Request for Bid #12-0114 Adult Detention Facility Master Control Upgrade Addendum #4

March 21, 2013

ADULT DETENTION FACILITY MASTER CONTROL UPGRADE WICHITA, KANSAS

Drawing Number: SD-A02				
Project Number:	Revised By:			
11074.001	HMN			
Date Issued:	Issued With:			
03/21/13	Addendum #4

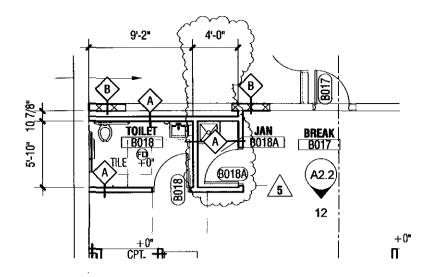
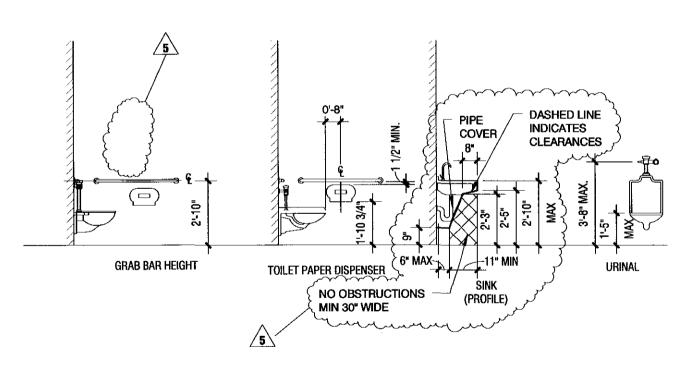
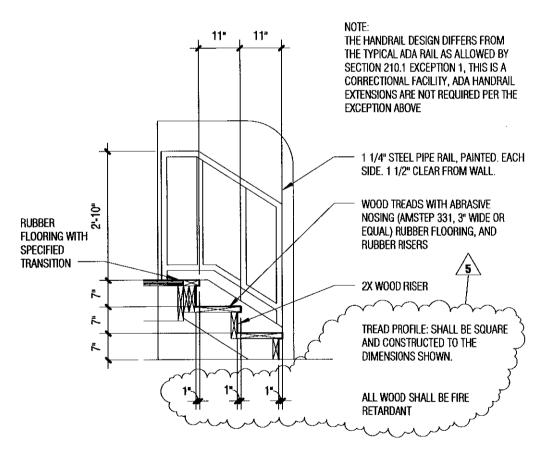
34. Sheet A2.2 - Casework Details

a. Revise per Supplemental Drawing SD-A02 as attached to this Addendum.
